**RESPONSE TO REQUEST FOR ADDITIONAL INFORMATION
IN REGARDS TO REQUEST FOR LICENSE AMENDMENT
INCREASED LICENSED POWER LEVEL
SALEM GENERATING STATION, UNIT NOS. 1 AND 2
FACILITY OPERATING LICENSE DPR-70 AND DPR-75
DOCKET NOS. 50-272 AND 50-311**

**ATTACHMENT 1
SALEM GENERATING STATION
UNIT NOS. 1 AND 2
FACILITY OPERATING LICENSE DPR-70 AND DPR-75
DOCKET NOS. 50-272 AND 50-311
RESPONSE TO REQUEST FOR ADDITIONAL INFORMATION
INCREASED LICENSED POWER LEVEL**

**SALEM GENERATING STATION
UNIT NOS. 1 AND 2
FACILITY OPERATING LICENSE DPR-70 AND DPR-75
DOCKET NOS. 50-272 AND 50-311
CHANGE TO FACILITY OPERATING LICENSES**

Figure 3.4-2 . Salem Unit 1 Reactor Coolant System Heatup Limitations
 Applicable for Heatup Rates up to 60°F/HR for the Service
 Period up to 15 EFPY

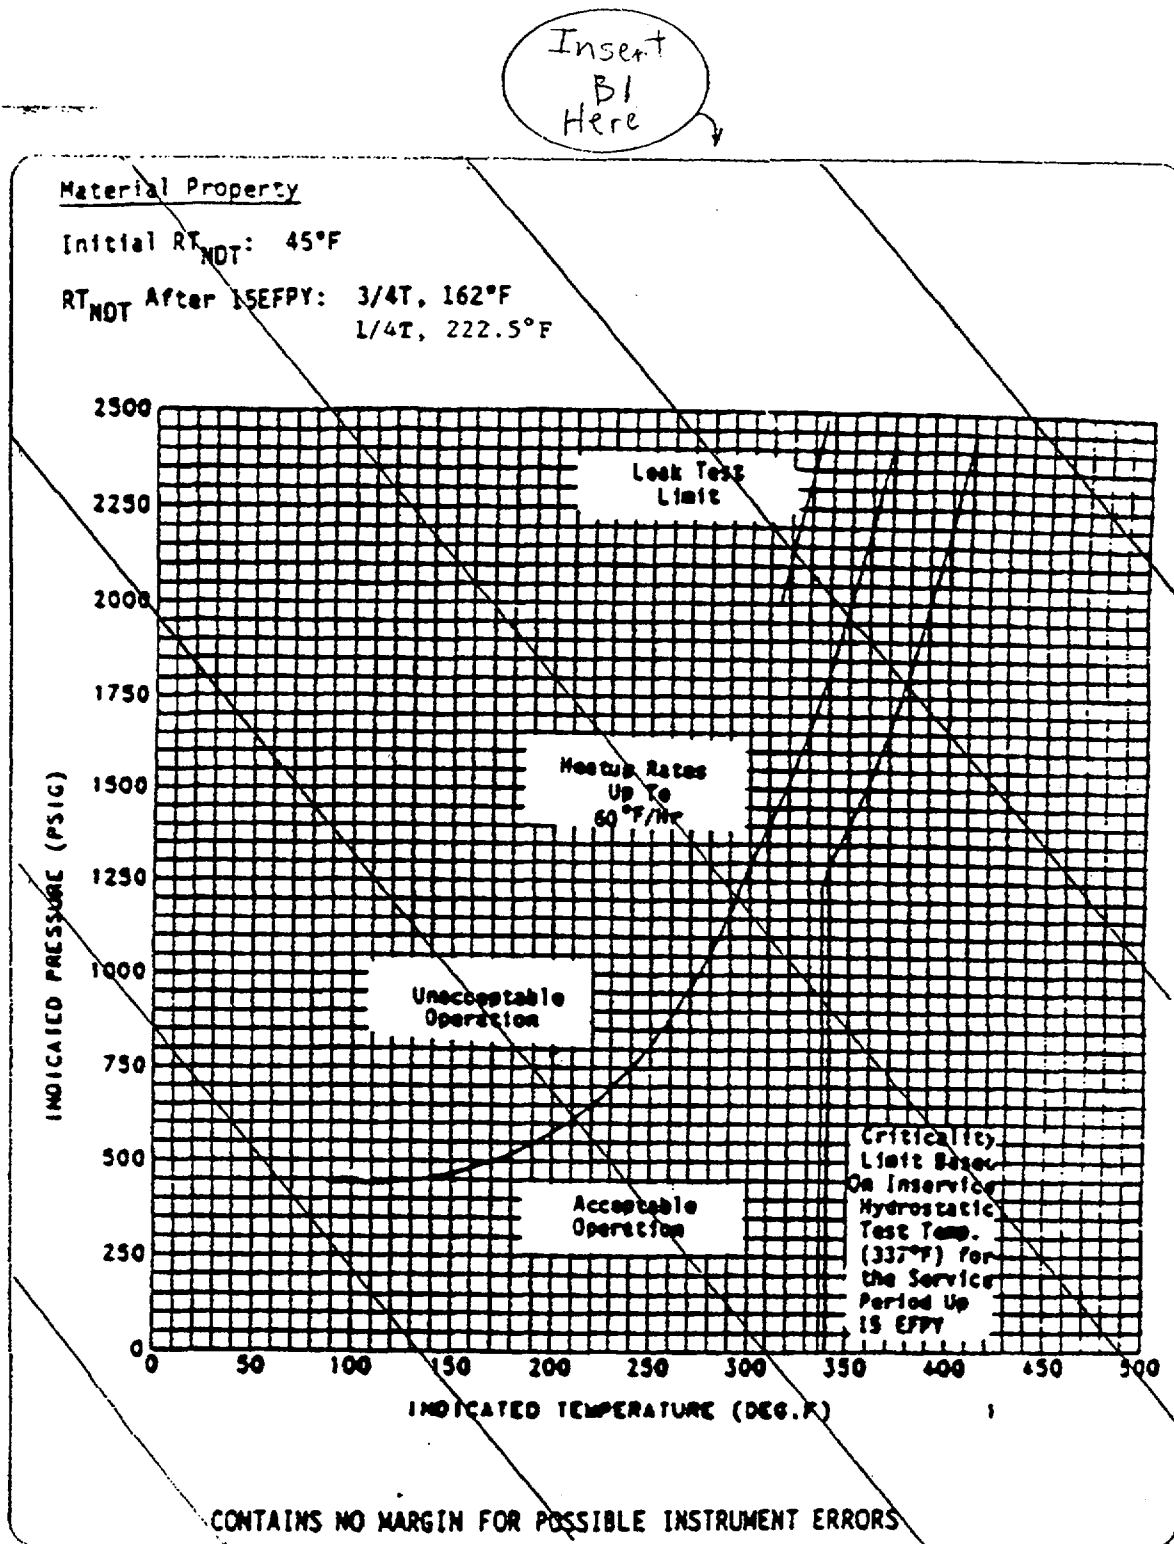
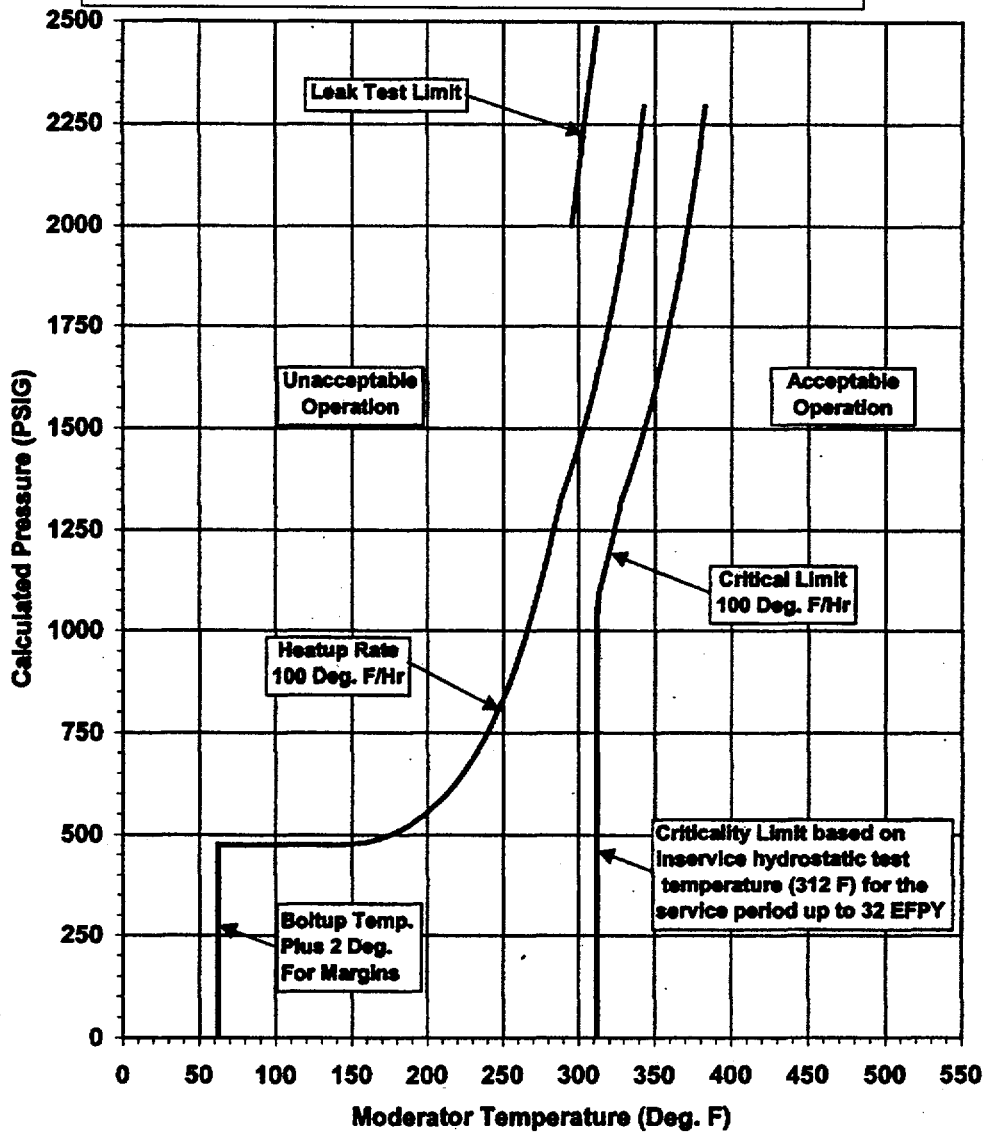
(32)

INSERT B1

1. Technical Specification Figures 3.4-2 and 3.4-3, Reactor Coolant System Heatup and Cooldown Curves, and their associated Bases are revised to support the increase in core power based on uprated fluence projections. The revised curves are applicable for the service period up to 32 effective full power years (EFPY). The maximum heatup rate for Figure 3.4-2, Reactor Coolant System Heatup Limitations, is being changed from 60°F/hr to 100°F/hr. The revised curves are being adjusted to account for pressure and temperature instrument uncertainties and the curves are being extended to show minimum boltup temperature. The values in Bases Table B 3/4.4-1, Reactor Vessel Toughness Data, for Unit 1 and 2 are being updated to reflect information related to reactor pressure vessel integrity previously provided to the NRC in response to Generic Letter 92-01 and its supplement.

@1/4T	@3/4T
Initial RT _{NDT}	-56°F	45°F
RT _{NDT} after 32 EFPY	232°F	171°F

Figure 3.4-3 Salem Unit 1 Reactor Coolant System Cooldown Limitations
 Applicable for Cooldown Rates up to $100^{\circ}F/HR$ for the Service
 Period up to **15** EFPY

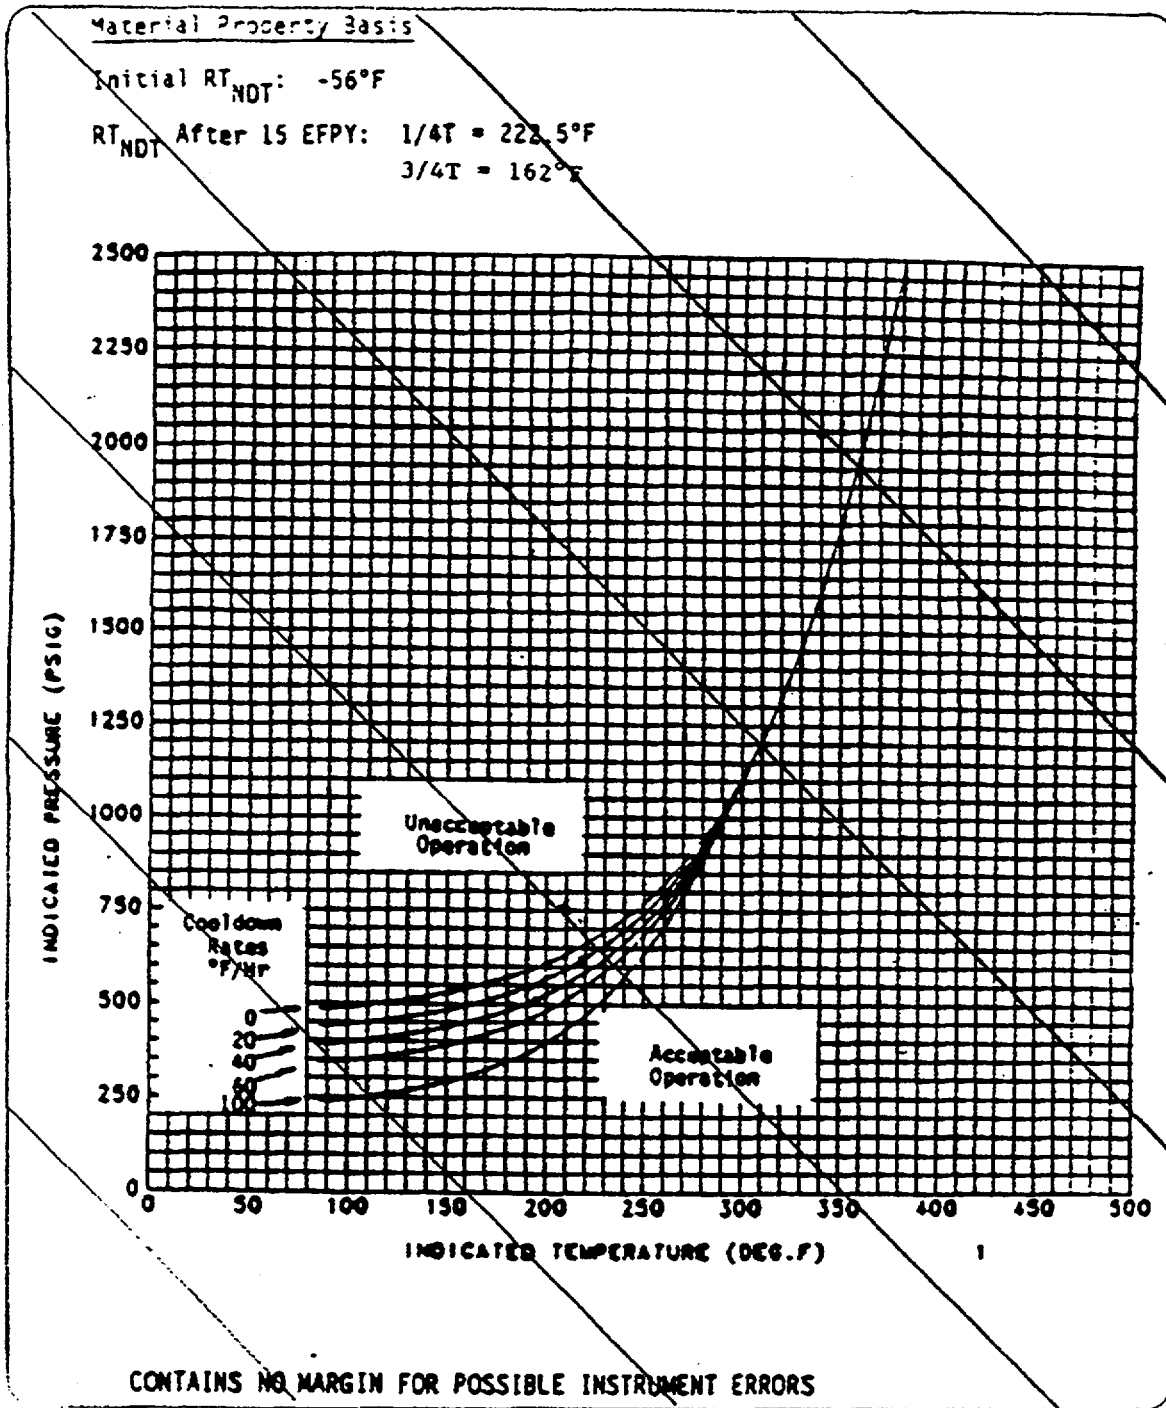
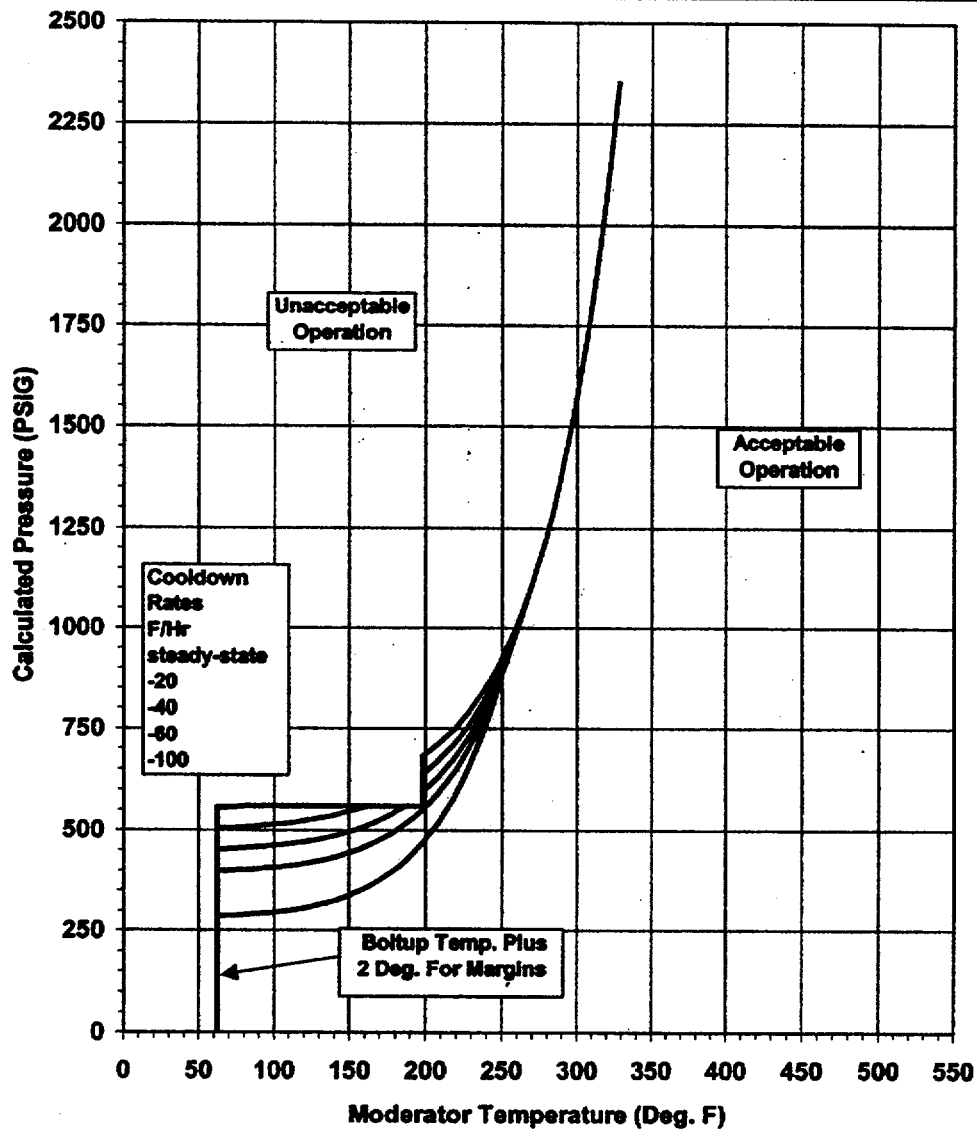
32

INSERT C1

@1/4T	@3/4T
Weld 3-042C		Plate B2402-1
Initial RT _{NDT}	-56°F	45°F
RT _{NDT} after 32 EFPY	232°F	171°F

SALEM UNIT 2 REACTOR COOLANT SYSTEM COOLDOWN
LIMITATIONS APPLICABLE FOR THE FIRST 15 EFY
WITH MAXIMUM COOLDOWN RATE OF 100 F/HR; CURVE
CONTAINS NO MARGIN FOR INSTRUMENT ERRORS.

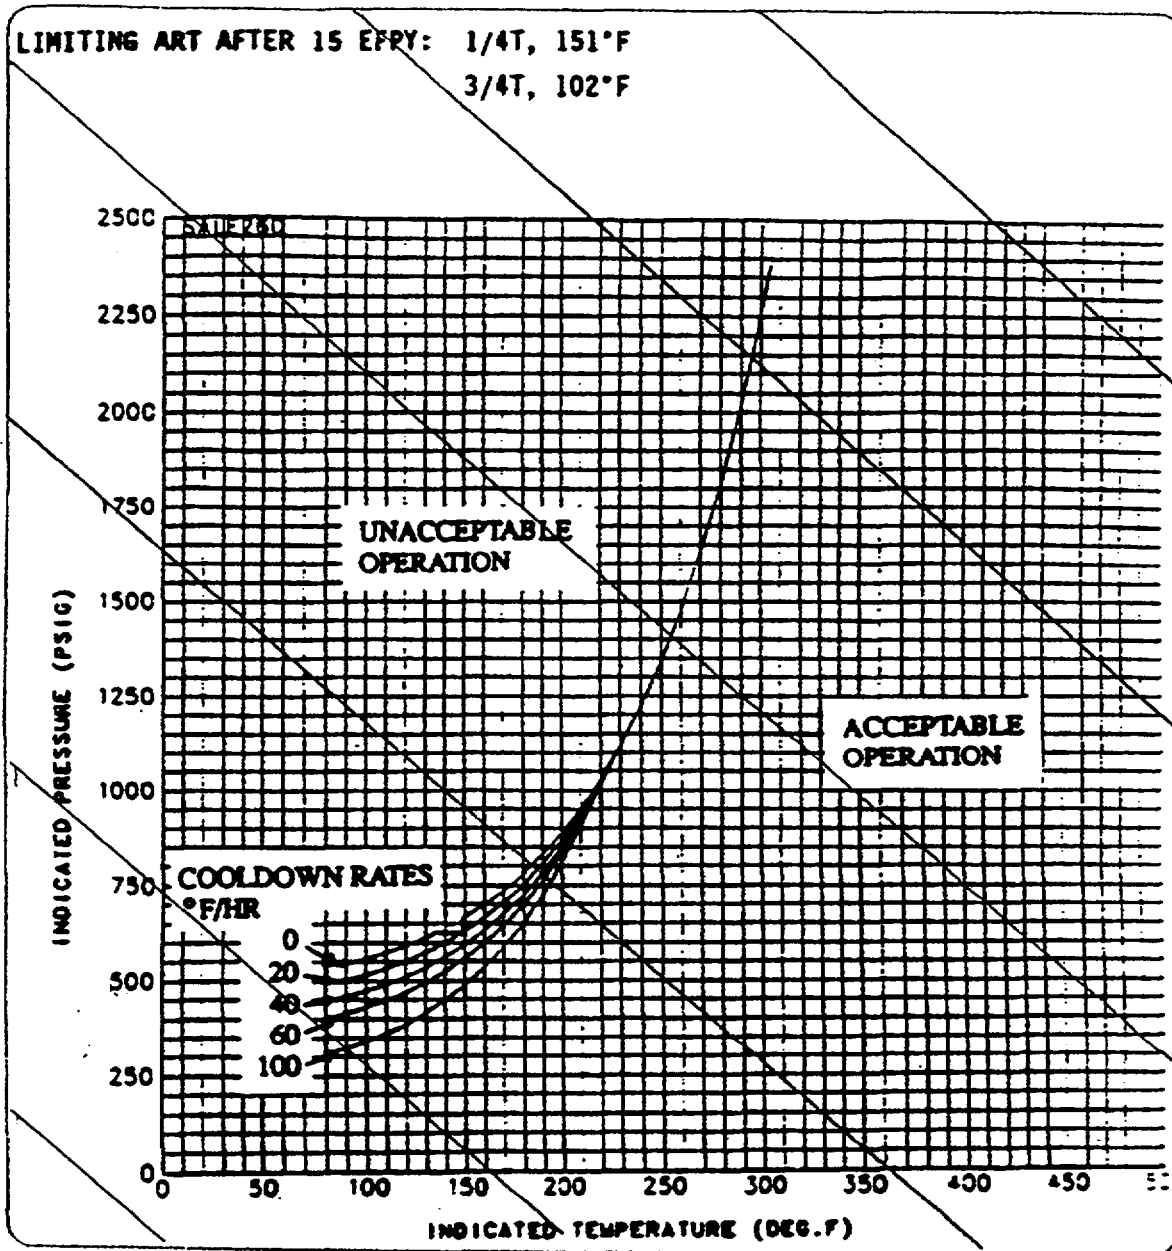
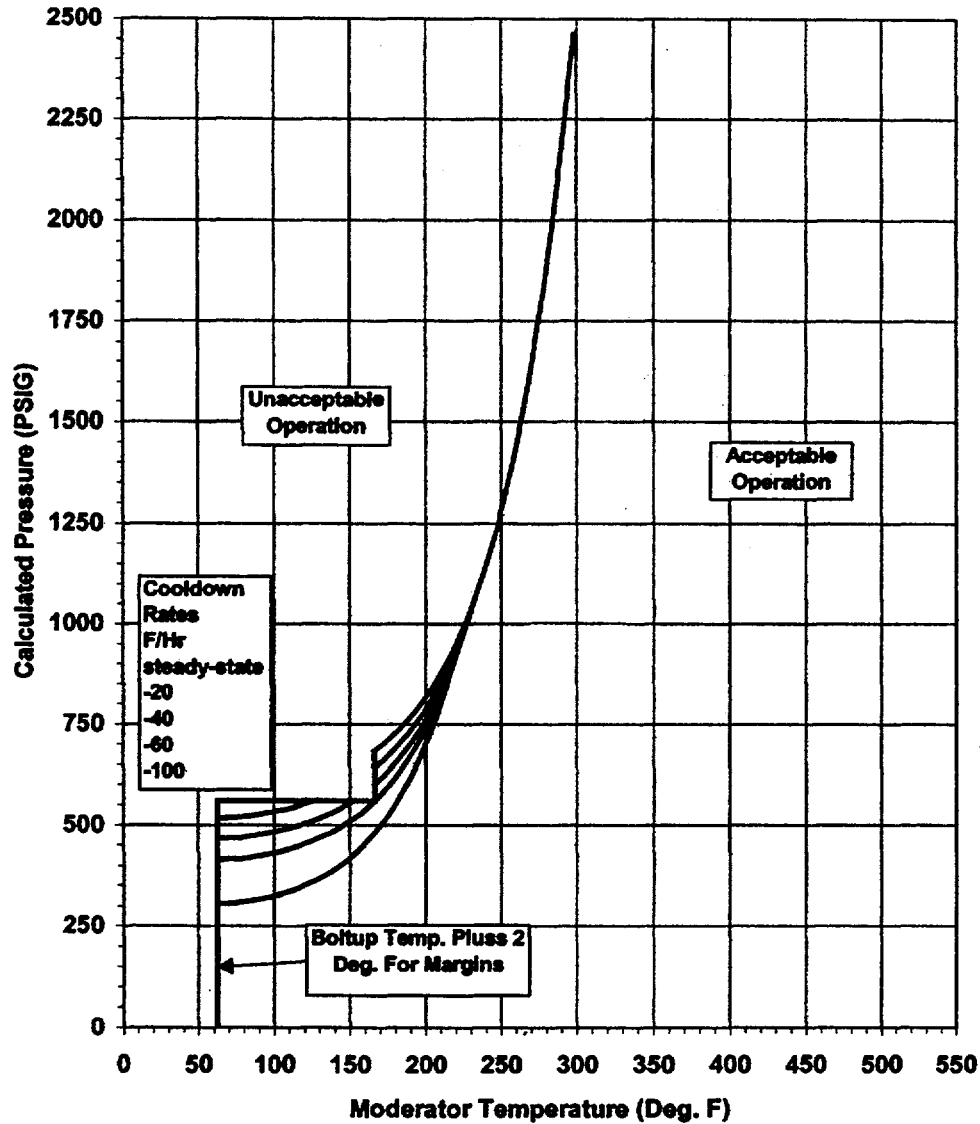
32

RT_{NDT} after 32 EFPY: 1/4T 199°F
 3/4T 140°F
